SERVICE BULLETIN

SB-AG-95

RUDDER PEDAL INTERFERENCE CORRECTION

Affected Aircraft Models	Serial Number Range
S2R-T660 DC/DC	196DC & BELOW

Figure 1

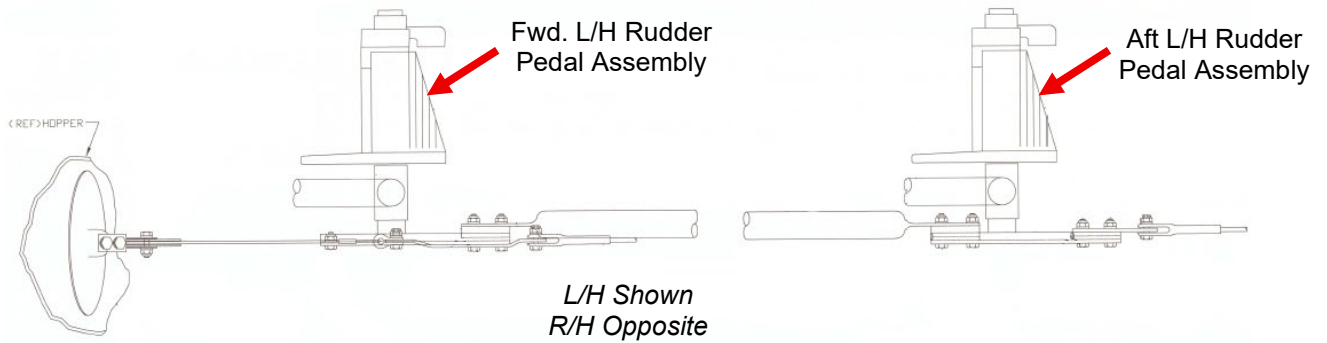
1. Remove existing L/H and R/H forward rudder pedal assemblies.
2. Install L/H and R/H rudder assemblies included in kit (reference Figure 1).

Figure 2

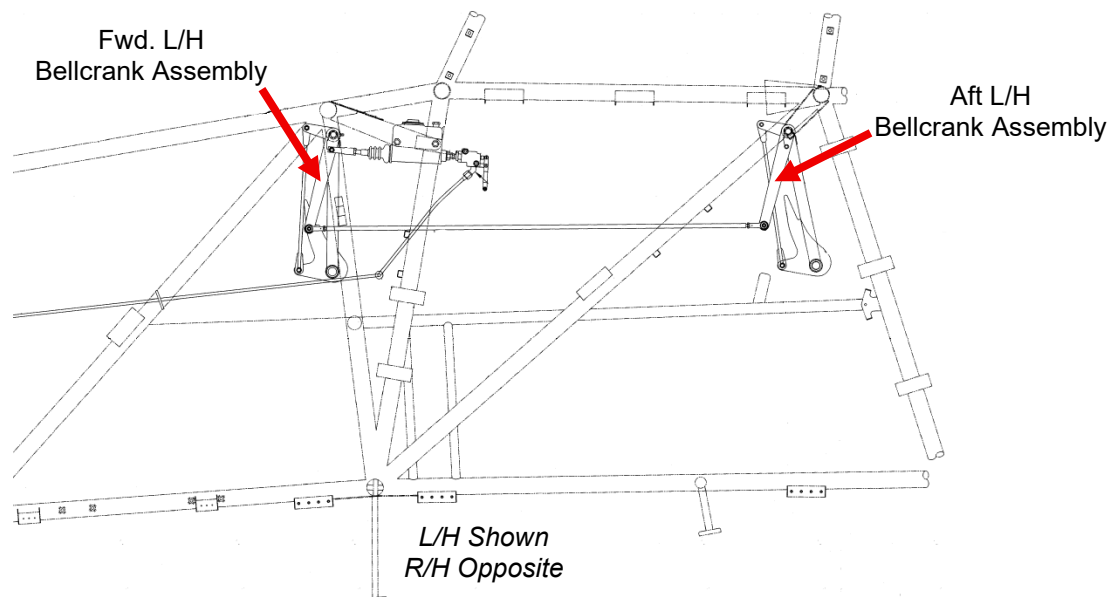
3. Remove existing L/H and R/H forward and aft bellcrank assemblies (reference Figure 2).
